25th July 2025

Ref: 16087-005 RO

## BEARS DOWN WIND FARM RE-POWERING – CHANGE FROM 5 TURBINE LAYOUT TO 4 TURBINE LAYOUT BY REMOVING T1

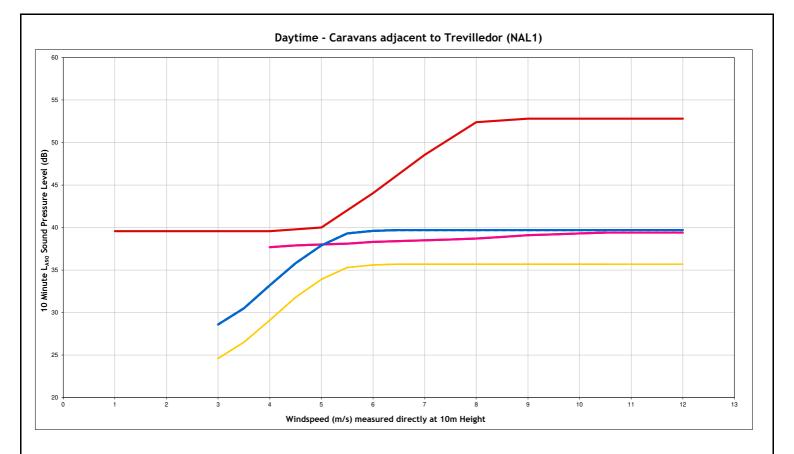
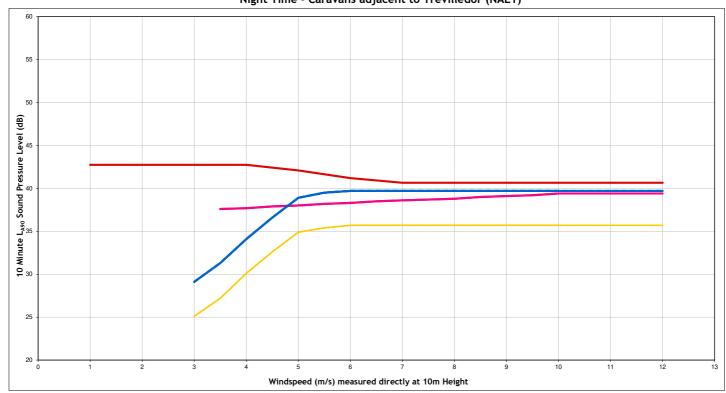
A lesser noise impact would results from this reduction un turbine numbers and to quantify this change in layout, noise predictions have been updated to compare the 5 x turbines layout (as predicted in TNEI report 16087-003 December 2023) with the 4 x turbines layout (T1 removed). The comparison is provided in detail for all receptors (i.e. residential properties) in the Figure A1.3a-I found in Annex 1 appended to this letter. The results indicate a decrease in predicted noise levels across the site. The most notable reductions occur as expected at receptors to the east (NAL1 and NAL2) where predicted levels have decreased by approximately 4dB.

The revised four-turbine layout results in lower predicted noise levels, offering an overall improvement in acoustic impact—particularly for receptors to the east of the site. It should be noted that this change of layout does not affect the Site Specific Noise Limits established previously. A key conclusion from the December 2023 report was "The final choice of turbine would, however, have to meet Site Specific Noise limits which should form the basis of any noise conditions." and this conclusion remain valid.
